Serial No. 09/543,958  
Reply Filed August 27, 2003

### REMARKS

FIG. 2

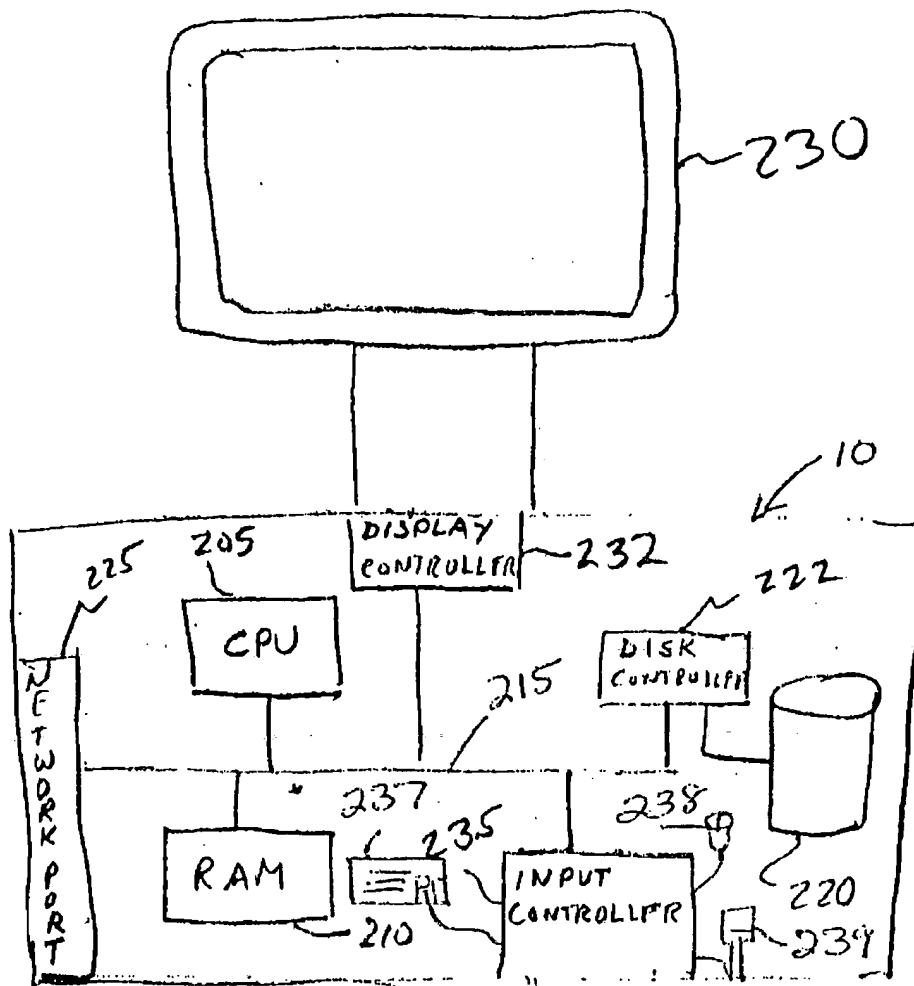
Typographical errors were corrected on pages 9, 10, 16, 17 and 19 of the specification. In Fig. 2, previously omitted reference numerals 10 and 215, and a keyboard, mouse and microphone, and corresponding reference numerals, were added based on the description on page 8, line 15 through page 9, line 7 of the specification. In Fig. 8 a typographical error has been corrected. Entry of these amendments is respectfully requested.
